Appl. No. 10/616,058
Amdt. dated July 15, 2005
Reply to Office Action dated May 17, 2005

AMENDMENTS TO THE DRAWINGS

Annotated Sheet Showing Drawing Changes

FIG. 1

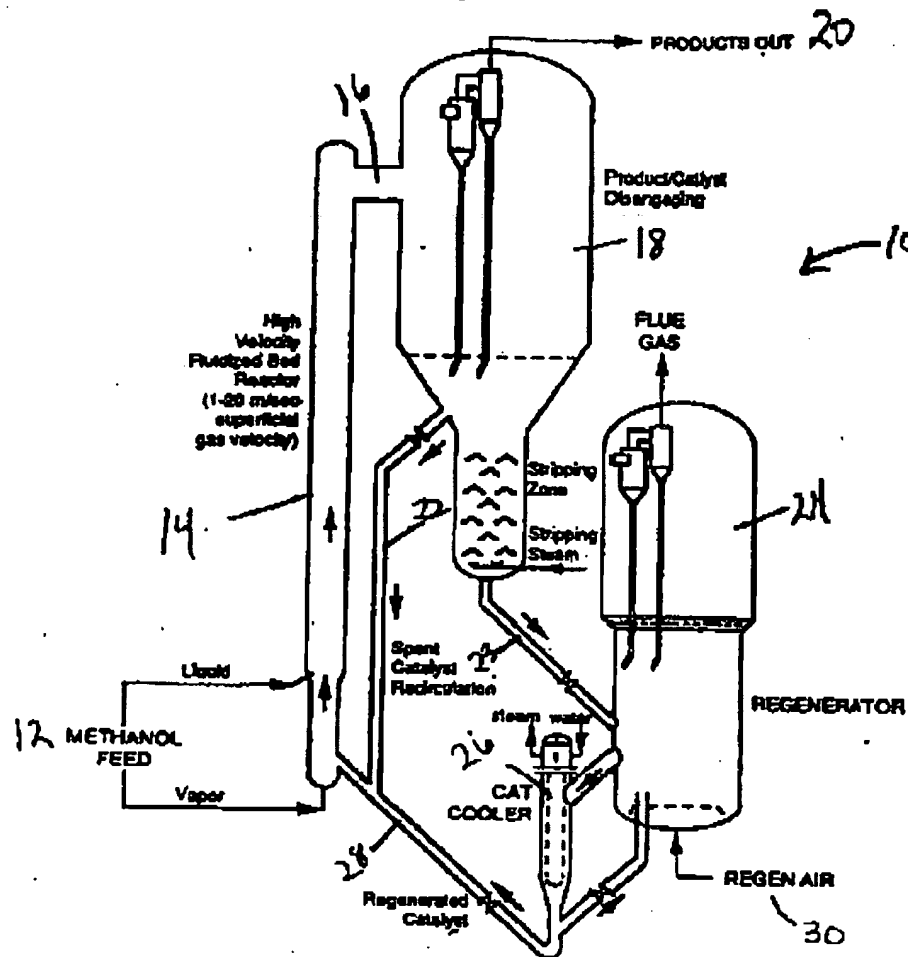
The attached Annotated Sheet Showing Drawing Changes is submitted in response to the objection to the drawings, with changes to the drawings shown in red ink. A replacement sheet will be submitted shortly to meet all formal drawing requirements.
